Department of Public Works  
**Engineering Division**  
Robert F. Phillips, P.E., City Engineer

**NOTICE OF ADDENDUM:  
ADDENDUM 1**

**CONTRACT NO. 7850  
YUMA DRIVE RESURFACING ASSESSMENT DISTRICT - 2017**

YUMA RESURFACING WITH UTILITIES	SHEET NO.
PROJECT NO. 11435	U-8
STORM SEWER SCHEDULE	
CITY OF MADISON

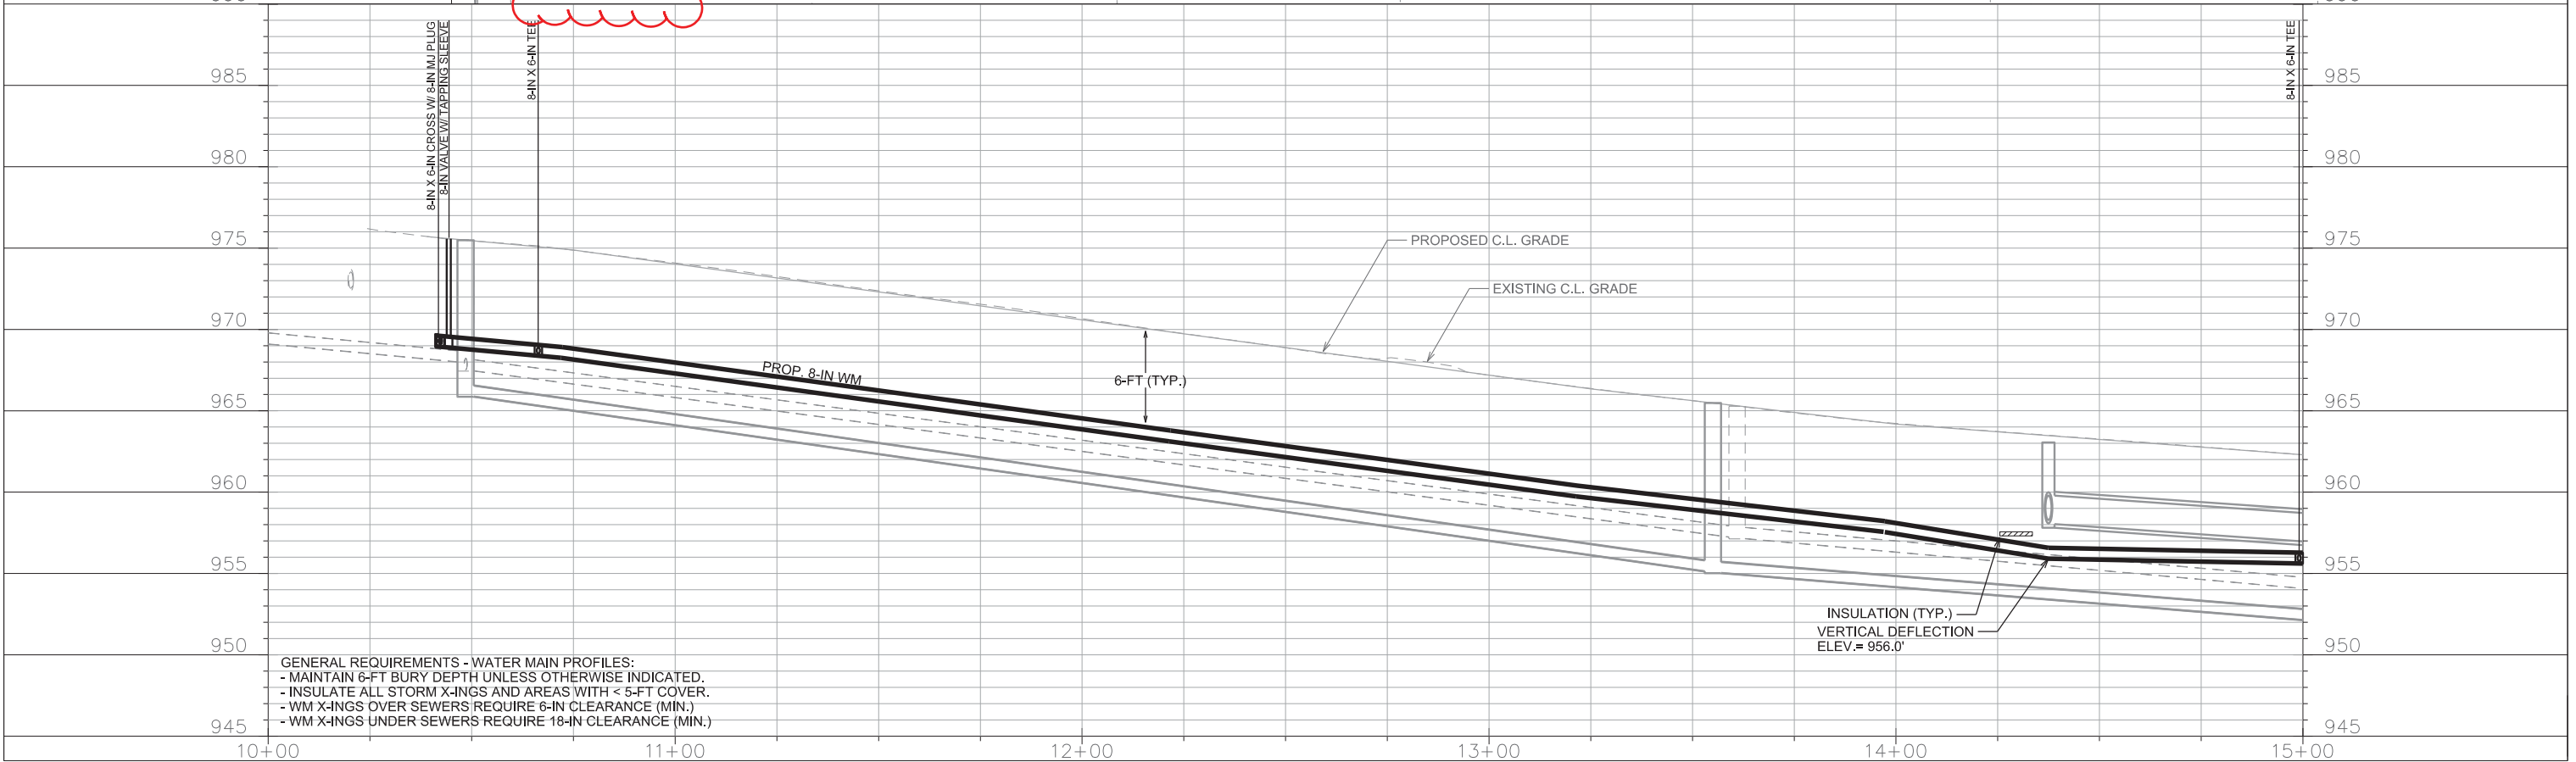
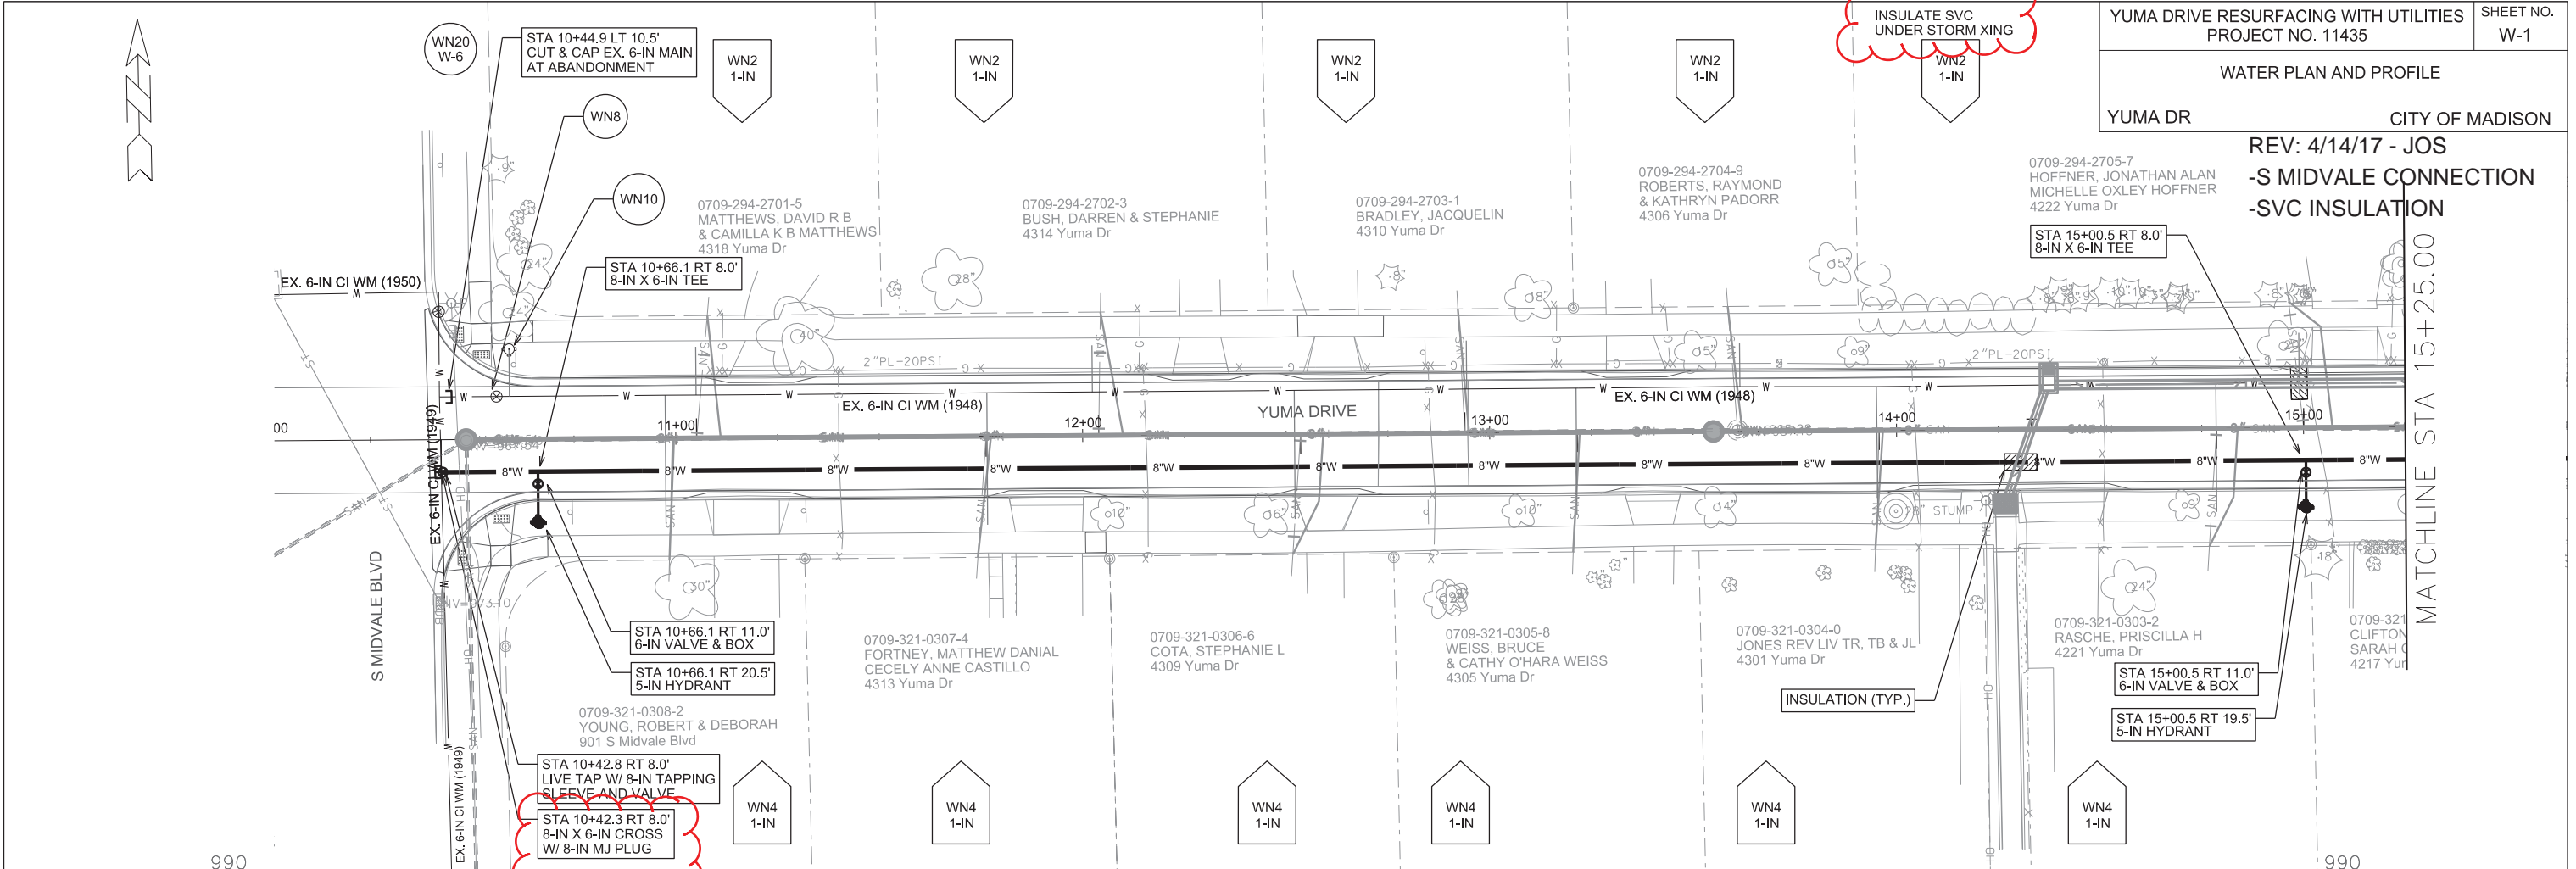
- Insert Sheets U-8 (revised 4-17-17)
  - Revised sheet to clarify S-11 structure type in Storm Sewer Schedule.
- Insert Sheets W-1 to W-11 (revised 4-14-17)
  - W-1: Revised S Midvale connection and insulated water lateral.
  - W-2: Service laterals insulated at storm sewer crossings.
  - W-3: Service reconnect at 4108 Yuma and Hiawatha intersection valves.
  - W-4: Revised Cherokee intersection connections.
  - W-5: (reprint only)
  - W-6: Revised S Midvale connection information.
  - W-7: (reprint only)
  - W-8: (reprint only)
  - W-9: Revised Cherokee connection information.
  - W-10: Revised Cherokee connection information.
  - W-11: Revised estimate of materials based on above changes.

\*REV 4/17/2017 KDF

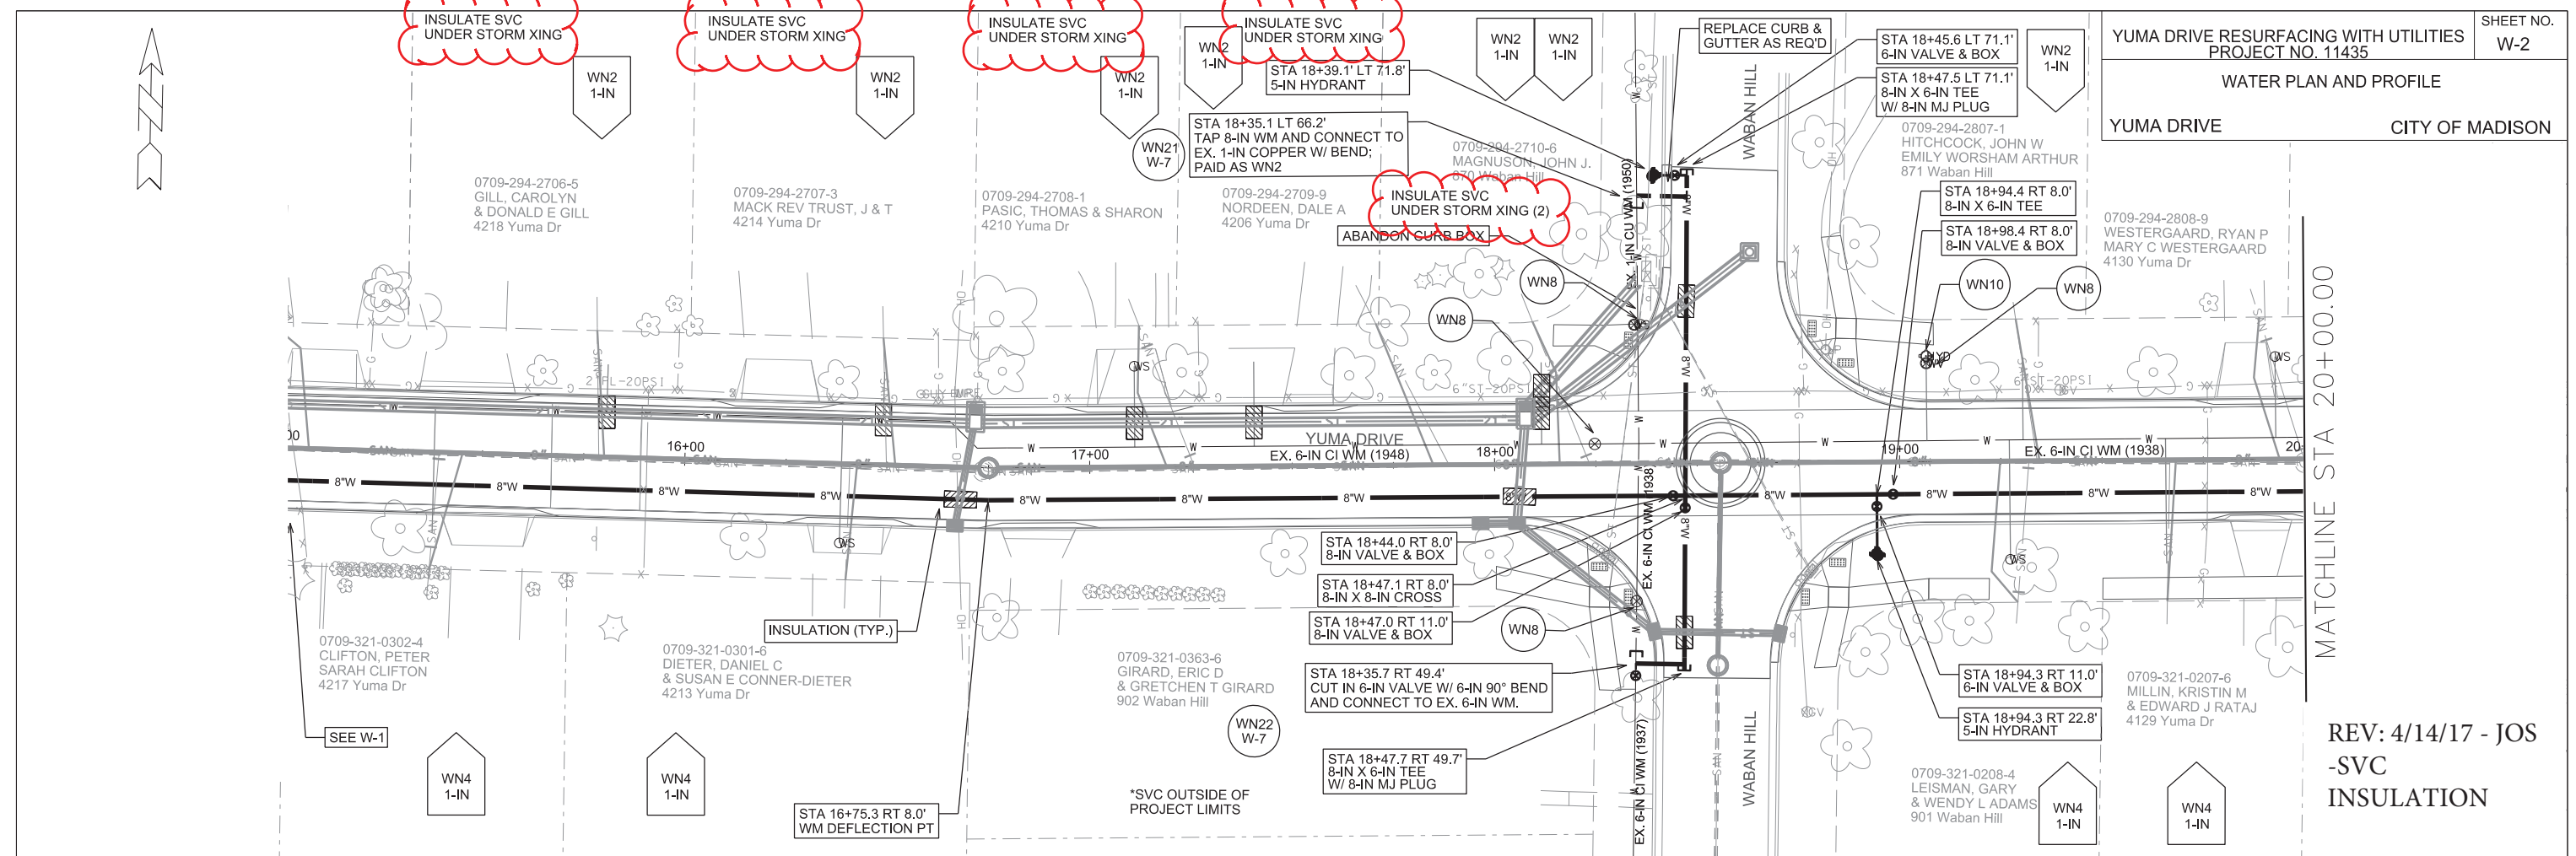
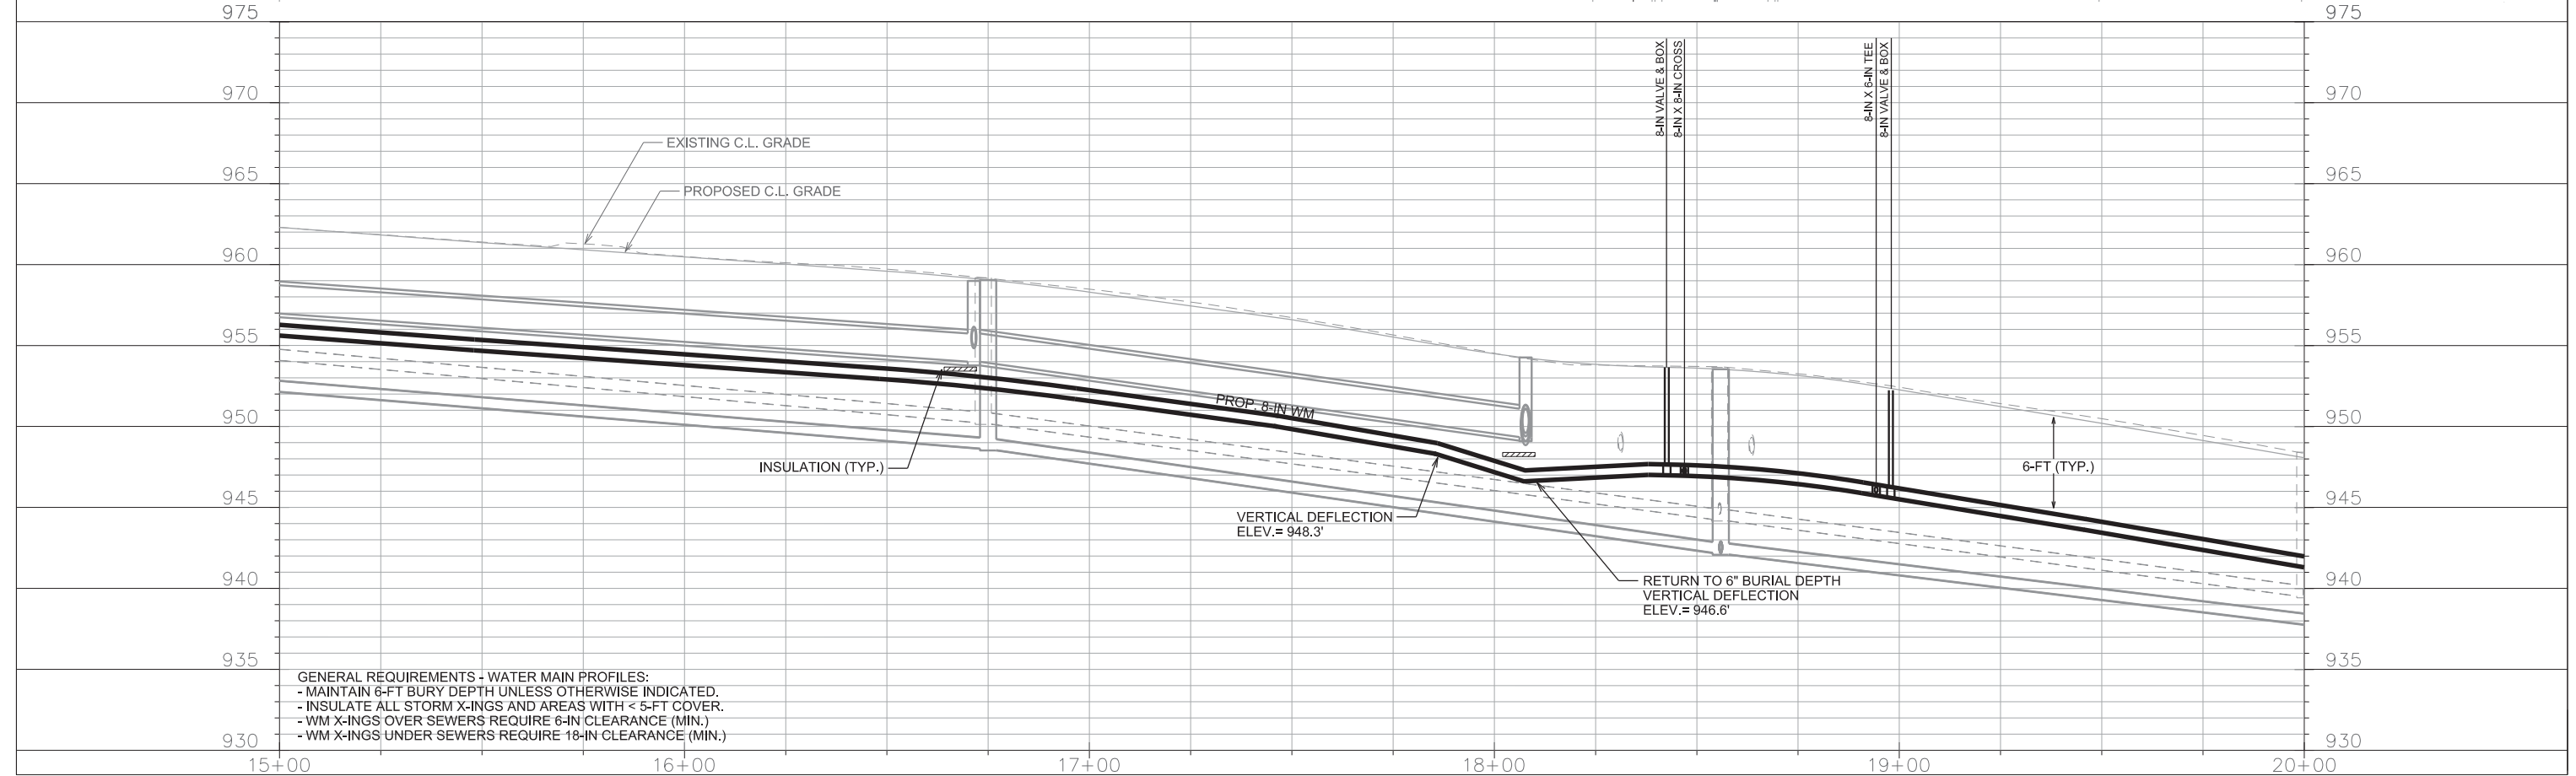
REV: 4/14/17 - JOS  
 -S MIDVALE CONNECTION  
 -SVC INSULATION

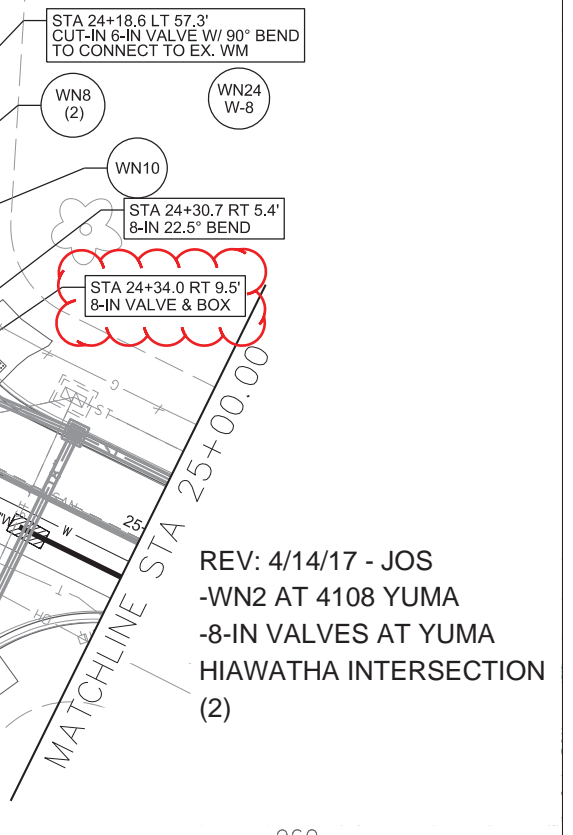
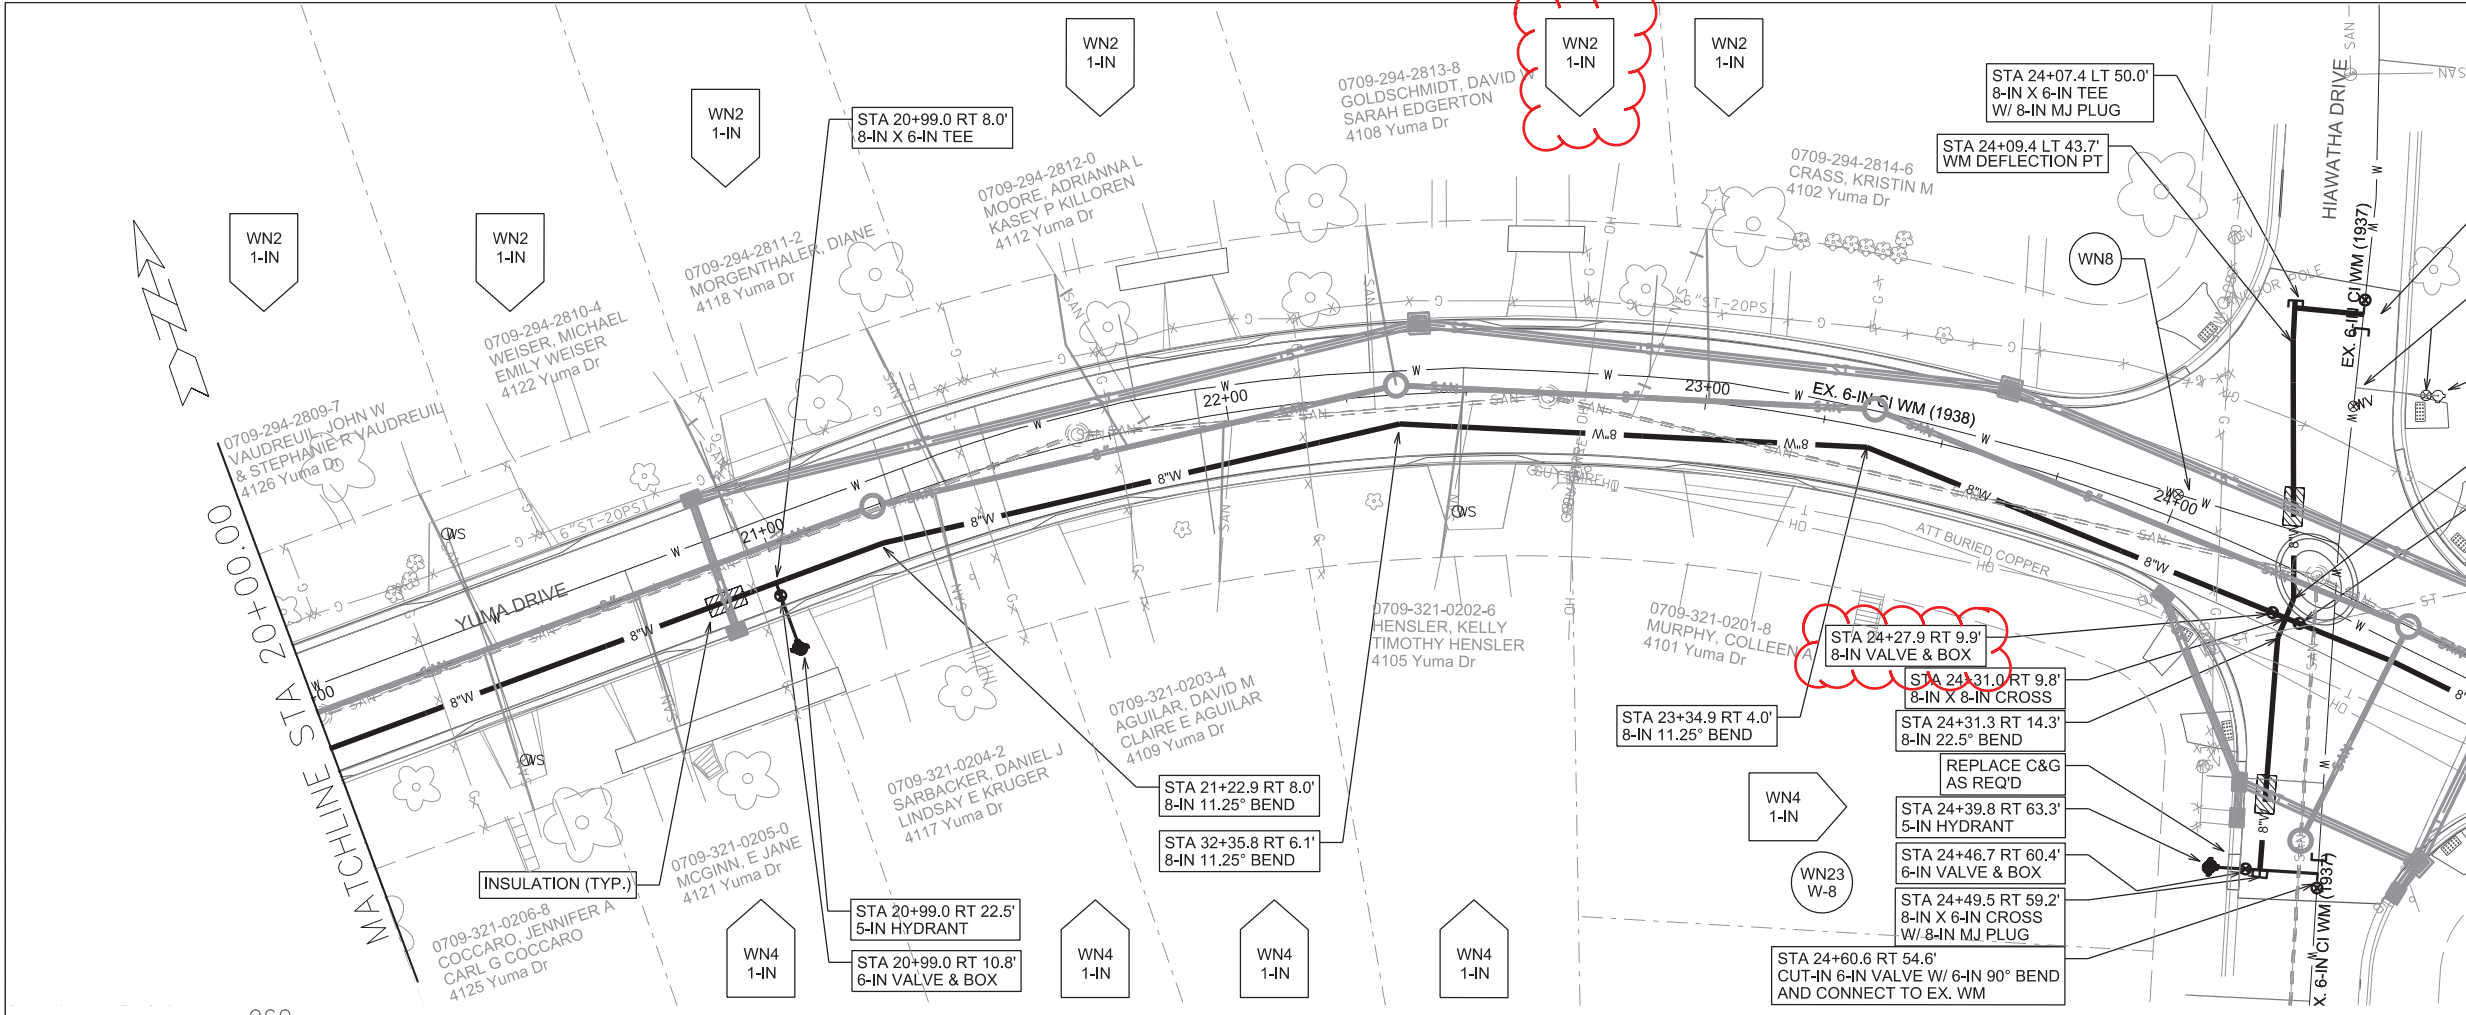
REV: 4/14/17 - JOS  
 -SVC  
 INSULATION
